Subject: Sanderling Avenue Residential Flat Buildings Environmental Impact Statement (SSD-82066472) (Mid-Coast)

Attachment 1: Detailed Comments for Sanderling Avenue Residential Flat Buildings Environmental Impact Statement (SSD-82066472)

Figure 1: Nearmap imagery from May 2010 showing relatively uniform vegetation.

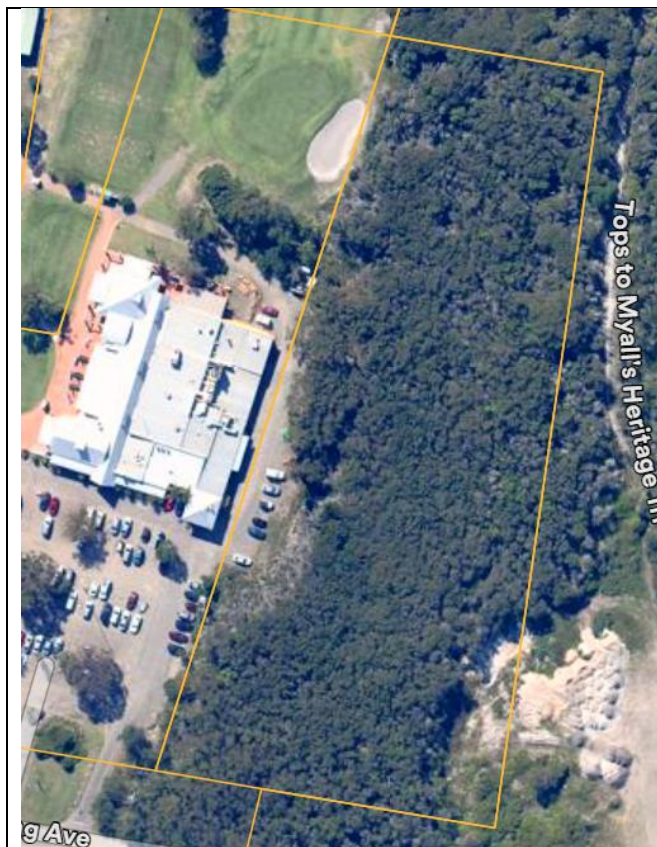
The assessment has identified two PCTs on the subject land, PCT 3544 and PCT 3555. The justification for the selection of PCT 3555 is based on the absence of specific canopy trees, particularly *Eucalyptus pilularis*. Further justification is needed to demonstrate why areas selected as PCT 3555 are not a modified form of PCT 3544 (i.e. where *Eucalyptus pilularis* has been reduced or removed).

Aerial imagery from 2010 shows relatively uniform vegetation across the site, prior to disturbance events including a fire (2010) and clearing in (2017) (**see Figures 1-3 below**). Data within the BDAR also identify *Eucalyptus pilularis* as present in the areas mapped as PCT 3555, including being listed as a dominant species in Table 6 of BDAR and within the Arborist Impact Assessment (AEP 2025).

4. Provide further justification for the selection of PCT 3555, or re-categorise areas of PCT 3555 to PCT 3544.
5. If this matter cannot be resolved via the additional detail provided, arrange a site visit with CPHR to verify PCT selection.
